Subject: DRAFT Response to U.S. EPR Design Certification Application RAI No. 266, FSAR Ch 6, Supplement 7, Questions 06.02.01.04-4 and 06.02.02-33
Sent Date: 6/30/2010 1:36:55 PM
Received Date: 6/30/2010 1:37:03 PM
From: BRYAN Martin (EXTERNAL AREVA)

Request for Additional Information No. 266, Supplement 7

U.S. EPR Standard Design Certification

Docket No. 52-020

Figure 06.02.01.04-4-1—MSLB Containment Peak Pressure Comparisons

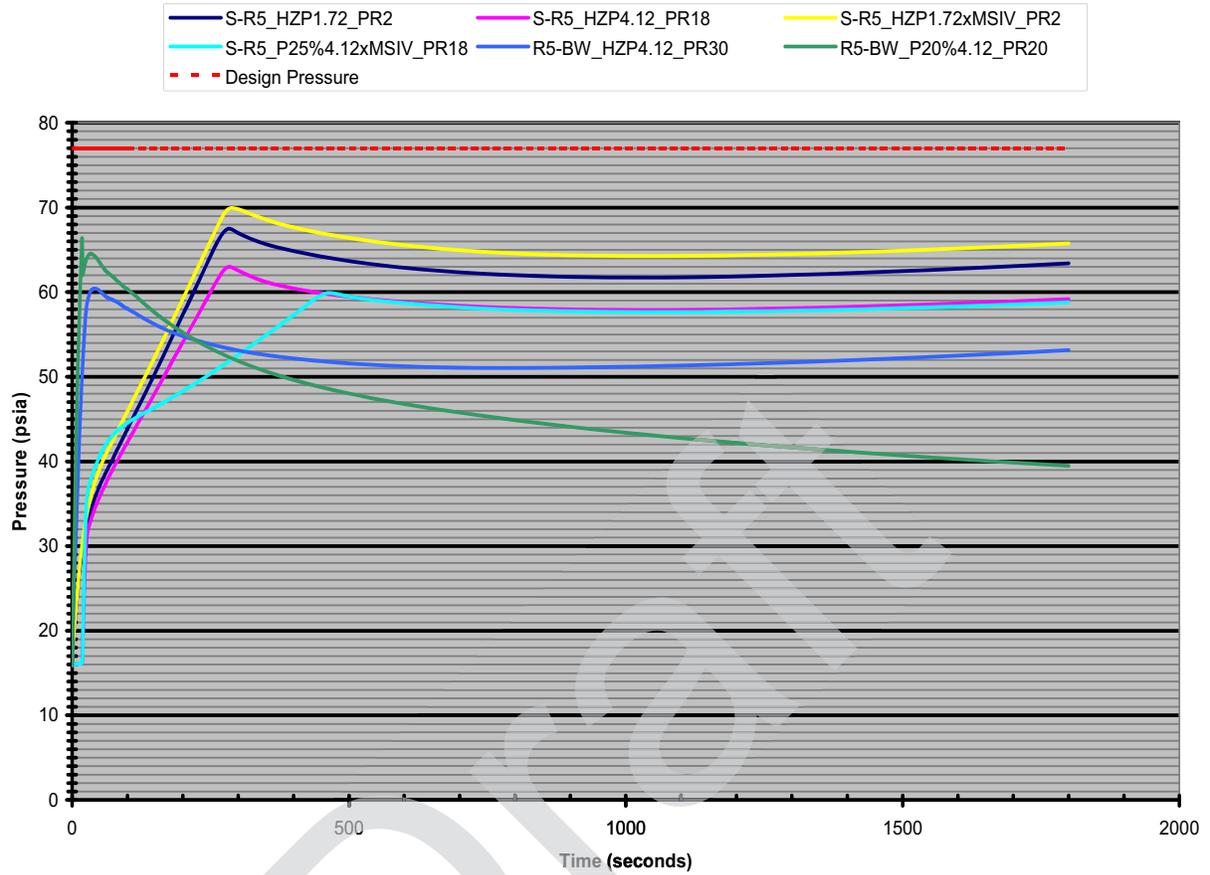
This question relates to conservativeness of the secondary system break mass and energy release calculations in FSAR Section 6.2.1.4. In RAI #82 6.01.02.04-1d the staff questioned the assumptions used to calculate reactor power following a main steam line break and the effect of these assumptions on containment analysis. In the response AREVA provided a curve of reactor power vs. time for the MSLB case calculated to produce the highest calculated containment temperature and pressure. This was for a postulated double ended break with the reactor at an initial power level of 50%. Offsite power was assumed to remain available so that the reactor coolant pumps would continue to operate. The break flow was assumed to be limited by the area of the flow restrictors in the steam generator nozzles to 1.4 ft². The RELAP5/Mod2-B&W computer code was used to model the reactor system. No return to power was calculated even though the most reactive control rod was assumed to be stuck and to not enter the core following reactor trip.

AREVA also evaluated the consequences of a main steam line break in FSAR Section 15.1.5 to determine the potential for reactor core damage. In these evaluations the S-RELAP5 computer code was used. For the limiting break a return to power was calculated which reached a maximum of 23.14% over a period of approximately 200 seconds. This energy generation is sufficient, if considered in the containment analysis to have a considerable effect on the calculated containment temperature and pressure. In the response to RAI #34 15.01.05-2, AREVA provided the results from the sensitivity study of postulated steam line breaks for which the potential for core damage was evaluated. Initial power levels of 100%, 60%, 25% and 0% were investigated using S-RELAP5. The core was calculated to return to power generation following reactor trip regardless of the initial power level. The staff understands that part of the reason that return to power was calculated for the Chapter 15 analyses but not for the Chapter 6 analysis, was that a much higher control rod shutdown margin was assumed for the Chapter 6 analyses as compared with the Chapter 15 analyses. Provide analyses of the containment response to postulated main steam line breaks for which the core physics assumptions are consistent or conservative as compared to those which the staff is reviewing to support the main steam line break analyses in FSAR chapter 15.

Figure 06.02.01.04-4-1 shows the results of the four U.S. EPR FSAR Tier 2, Chapter 15 S-RELAP5 methodology-based GOTHIC calculations previously mentioned, together with GOTHIC calculations (RELAP5-BW M&Es) of the limiting U.S. EPR FSAR Tier 2, Chapter 6 analysis of record (DEG MSLB from 20 percent RTP) (green curve) and a U.S. EPR FSAR Tier 2, Chapter 6-based double-ended MSLB from HZP (blue curve). The results indicate:

- The limiting U.S. EPR FSAR Tier 2, Chapter 15-based S-RELAP5 HZP 1.72ft² MSLB calculated peak containment pressure (with no credit taken for high P_{cont} pressure isolation) is not bounded by the limiting U.S. EPR FSAR Tier 2, Chapter 6-based RELAP5-BW 20 percent power DEG MSLB calculated peak containment pressure.
- The limiting single failure in terms of containment consequences is the failure of the affected SG MSIV to close.
- The limiting U.S. EPR FSAR Tier 2, Chapter 15-based MSLB scenario in terms of containment consequences is the 1.72 ft² split MSLB from HZP EOC conditions with failure of the affected SG MSIV to close and no loss of offsite power (LOOP).

The overall results of the S-RELAP5/GOTHIC containment analyses indicate that the limiting Chapter 15-based HZP MSLB scenario is not bounded by the corresponding U.S. EPR FSAR Tier 2, Chapter 6 limiting case MSLB scenario although no credit is taken for high containment pressure (P_{cont}) isolation in any of the S-RELAP5 analyses.
